C-101 POST-RETRIEVAL/CLOSURE SAMPLING

MEETING NOTES - Attachment

DATE: April 28, 2015

SUMMARY OF 241-C-101 ORSS SAMPLING TO SUPPORT CLOSURE

Figure-2. Approximate C-101 Planned and Actual Sample Locations (not to scale)

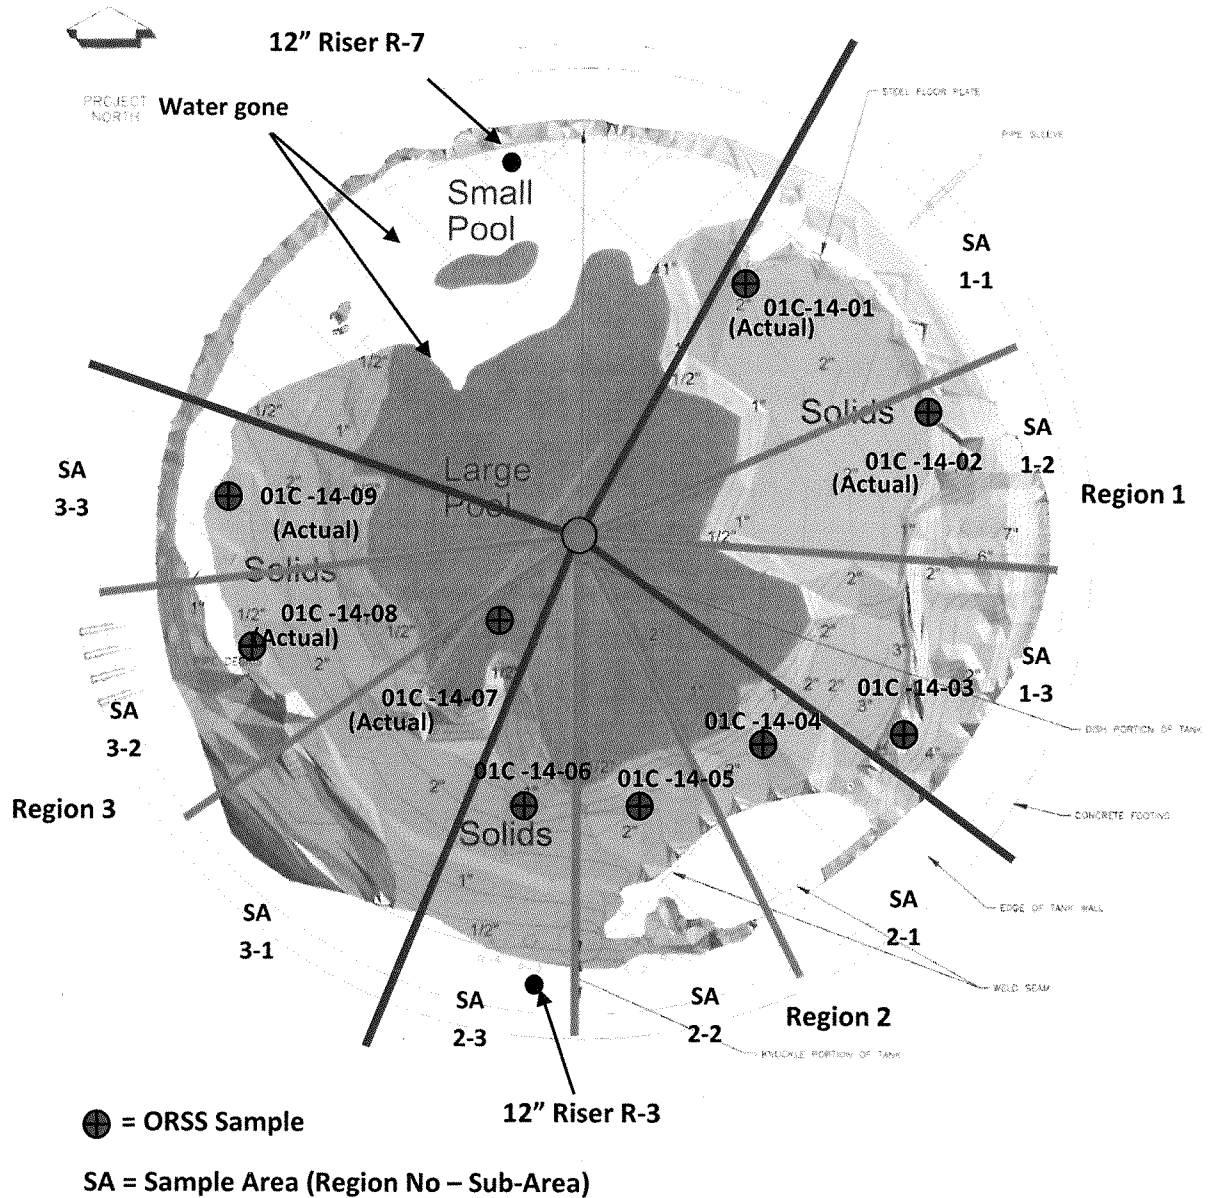
C-101 Sampling. The C-101 sampling design called for collection of samples using the ORSS of residual waste remaining on the tank floor after completion of retrieval activities. Figure 2 shows the planned (and actual) sample locations. At the time of sample planning, these locations were expected to be accessible for sampling. A total of nine (9) samples were planned to be collected from sample areas located within three primary sample regions (Regions 1, 2, and 3). The three samples from each Region were planned to be composited into one sample of approximately 450 grams representing the region. Sample jars are required to be $\frac{1}{2}$ or more full to ensure sufficient material to complete all analyses and if not full enough would be lowered back into the tank to collect additional material from the same location. As described in RPP-23403, three samples were preferred for each composite but the sampling objective would be considered achieved if sufficient solids were collected from less than three areas within the Region to complete the analyses.

Sampling objective achieved. Although not all samples required by the TSAP were collected, the sampling objective should be considered achieved and sampling complete because as indicated below, the collected sample material sufficiently characterizes the residual waste.

- The bulk of the tank waste solids is located in the sampled areas (Regions 1 and 3); therefore, the samples taken from these regions represent the bulk of the waste.

- The sample material collected is sufficient to characterize C-101 tank waste and C-101 sampling objectives were achieved. Consequently, further C-101 sampling is not necessary and post-retrieval sampling of C-101 can be considered to be complete and retrieval equipment can be demobilized.
- The collected samples will not be composited and each sample will be analyzed individually.
- Leach rate testing by the Pacific Northwest National Laboratories on the C-101 sample material is not necessary and sample material need not be set aside for this testing.
